ADDENDUM NO. 2

Access Road at the Erie County Agribusiness Park

Buffalo and Erie County Industrial Land Development Corporation (ILDC)

Date: May 9, 2025

JOB TITLE AND LOCATION: AGRIBUSINESS PARK 1526 EDEN EVANS CENTER ROAD ANGOLA, NEW YORK 14006	LIRO JOB NO.: 24-185-0135 SHEET OF 28 29
DRAWING TITLE: SIGNS, STRIPING AND LIGHTING PLAN	DRAWING NO. CS201

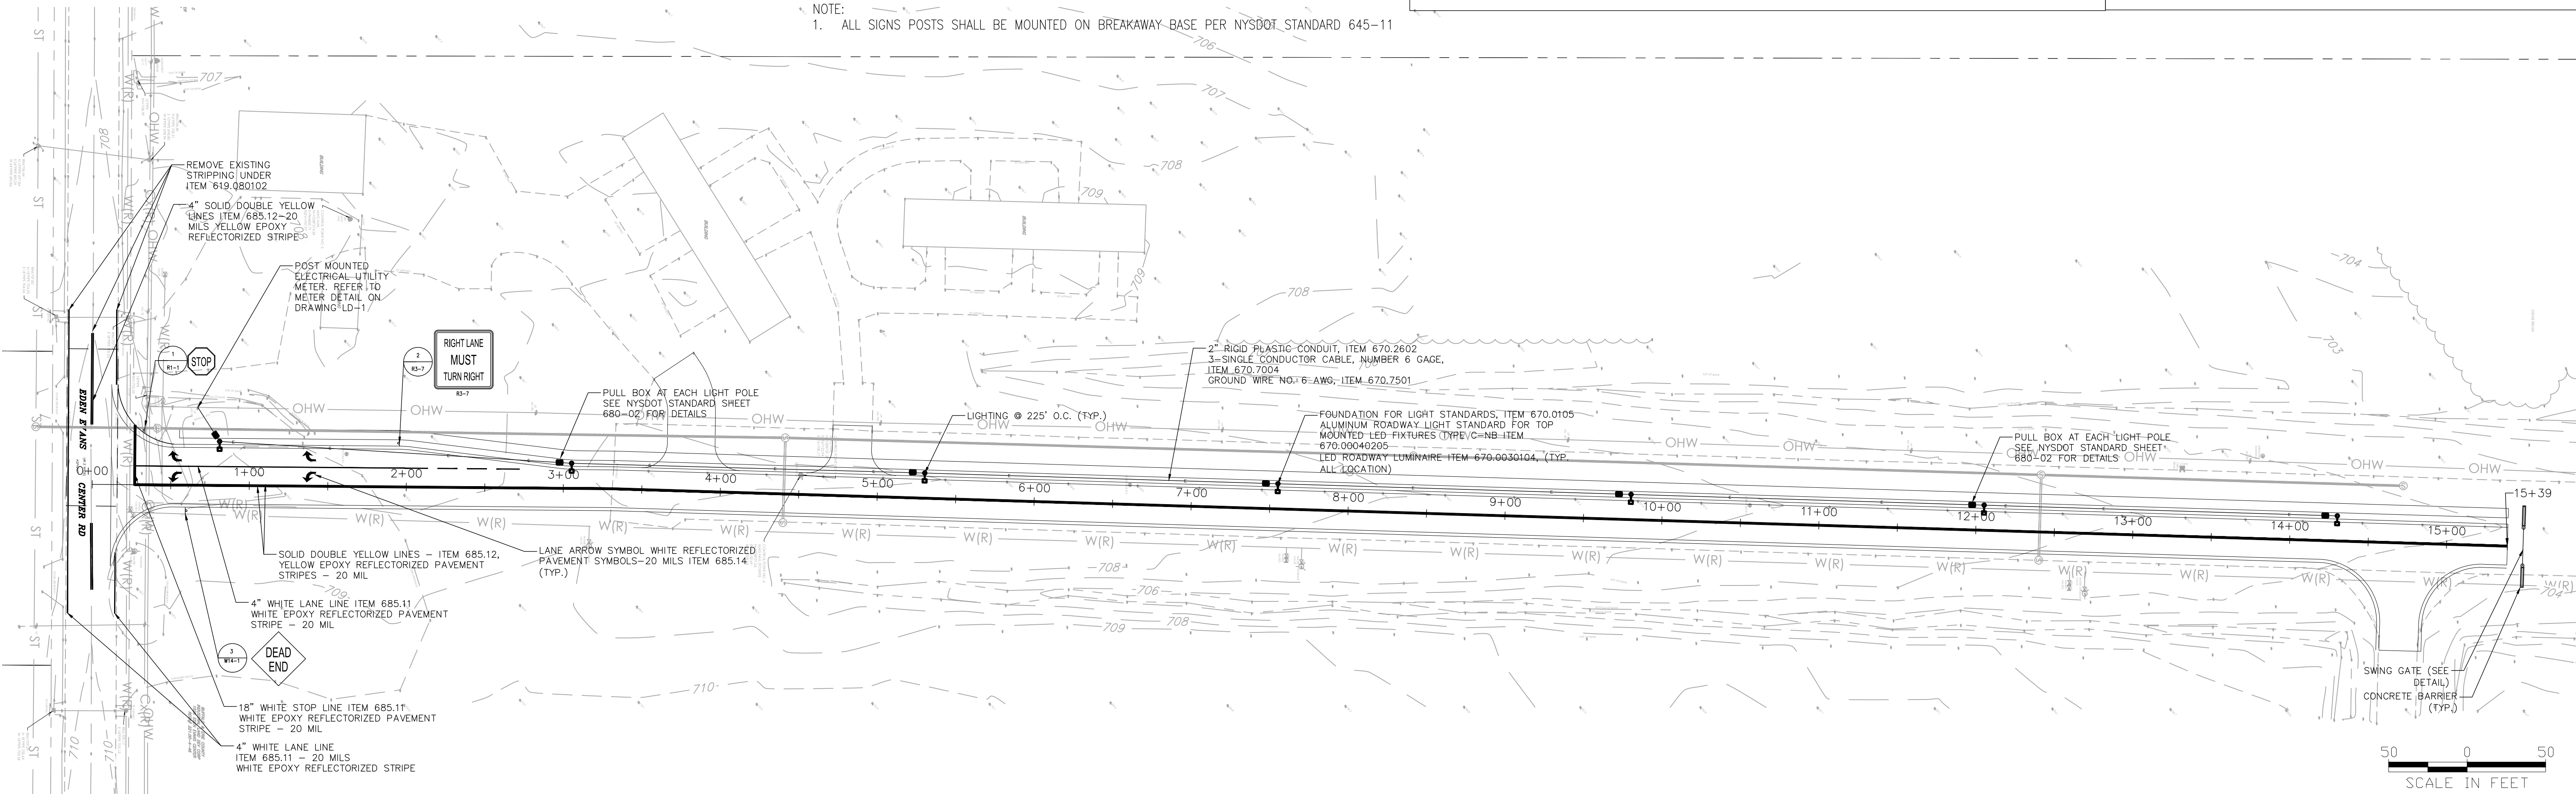
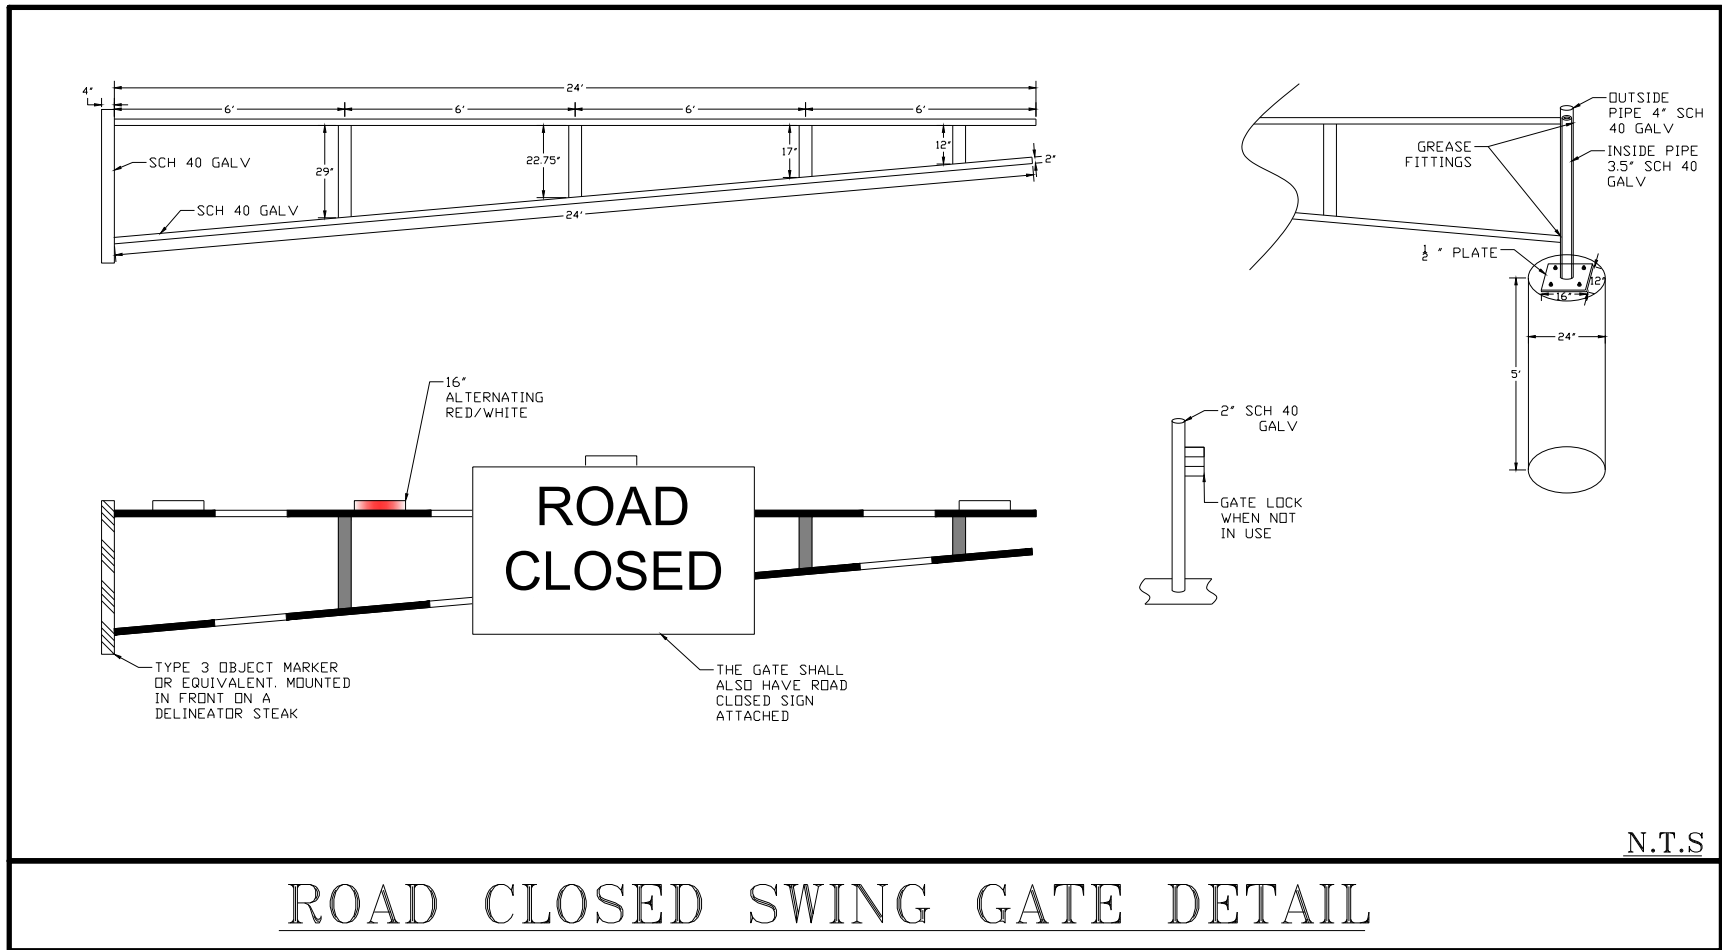
3. The quantity list states a quantity of 150 ea for item 670.3001 – Pullboxes Less Than 5 Cubic Feet, Inside Volume (Lighting), however, this item could not be located in the project documents and the quantity seems quite excessive. Additionally, if pullboxes are required, there are no dimensions provided. **Pull Box at each light pole, Qty is 7. Use pull box per NYSDOT 680-02. Updated Drawing CS201 and NYSDOT standard sheet attached.**

9. Please verify the quantity of Item 610.1601 Turf Establishment; 45,183 SY. Should this be SF? **Items are for reference only see 5 notes listed on the cover sheet of the project drawings. All work should be included in the lump sum bid.**
10. Drawing CS201 shows White Reflectorized Symbols yet there is no Item in the Bid Sheet. **Items are for reference only see 5 notes listed on the cover sheet of the project drawings. All work should be included in the lump sum bid.**
11. There appears to be a small amount of electrical conduit under proposed pavement between 1+25 & 2+75 lt. Note 9 on CS201 requires all conduit placed under the roadway shall be galvanized. There is no Item for this. **Use Item 670.2003.**
